Access Compliance Report Public Rights-of-Way (Curb Ramps)

Main Street: SHAKESPEARE_DR Cross Street: WIMBLETON_DR Location: NE

ADA ID: RPRK211215140846 Ramp Type: Type 1 - Perpendicular Diagonal Initial Pass/Fail: Fail Overall Compliance: No Severity Score: 16

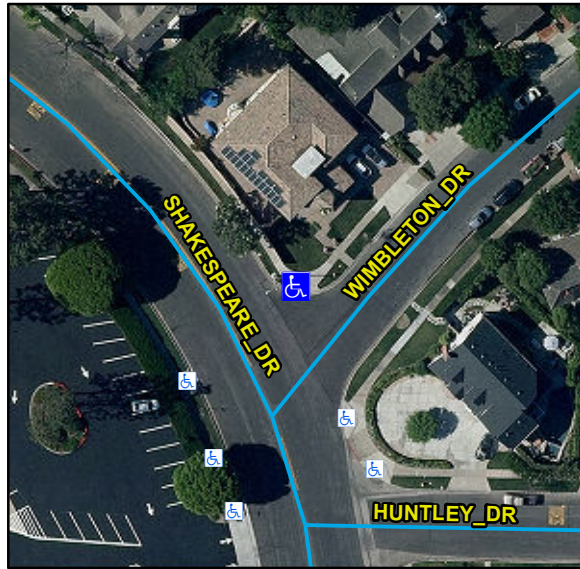
Compliance	Description	Data	Compliance	Description	Data
N/A	Ramp Length (in)	68	N/A	Flare Type LT	
Yes	Ramp Width (in)	48			N/A
No	Ramp Run Slope (%)	9.6	N/A	Flare Slope LT (%)	N/A
Yes	Ramp Cross Slope (%)	2	N/A	Flare Traversable LT	N/A
N/A	Landing Present	N/A	N/A	Flare Type RT	
N/A	Landing Length (in)	N/A			N/A
N/A	Landing Width (in)	N/A	N/A	Flare Slope RT (%)	N/A
N/A	Landing Run Slope (%)	N/A	N/A	Flare Traversable RT	N/A
N/A	Landing Cross Slope (%)	N/A	N/A	DWS Provided	N/A
N/A	Landing Movement Obstructed?	N/A	N/A	DWS Contrast	N/A
	Landing Movement Type	N/A	N/A	DWS Length (in)	N/A
N/A	Landing Shared	N/A	N/A	DWS Full Width	N/A
N/A	Clear Space	Yes	N/A	DWS Offset Left (in)	N/A
N/A	Clear Space To Crosswalk (in)	N/A	N/A	DWS Offset Right (in)	N/A
N/A	Marked Crosswalk 1	No	N/A	Marked Crosswalk 2	No
	Crossing 1 Direction	W		Crossing 2 Direction	S
	Marked Crosswalk 1 Width (in)	N/A		Marked Crosswalk 2 Width (in)	N/A

N/A	Ramp Inside Crosswalk 1	N/A	Yes	Ramp Inside Crosswalk 2	N/A
	Crossing 1 Slope (%)	5.1		Crossing 2 Slope (%)	8.7
	Crossing 1 Cross Slope (%)	0.4		Crossing 2 Cross Slope (%)	0.2
N/A	Gutter Ponding	N/A	No	Curb Slope	7.1
Yes	Gutter Lip Height (in)	0		Road Run Slope (%)	0.1
N/A	Gutter Run Slope (%)	N/A		Road Cross Slope (%)	8.8
N/A	Gutter Cross Slope (%)	N/A			
Yes	Overall Surface Condition: Acceptable		No	Perp Joint Present	No
	Cross Gutter Present?	No		Spandrel Present?	No
	Replace Cross Gutter?	N/A		Replace Spandrel?	N/A

Remove & Replace Curb Ramp With Two New Directional Ramps or Equivalent.

R304.2.2, R204.3, STD 1115
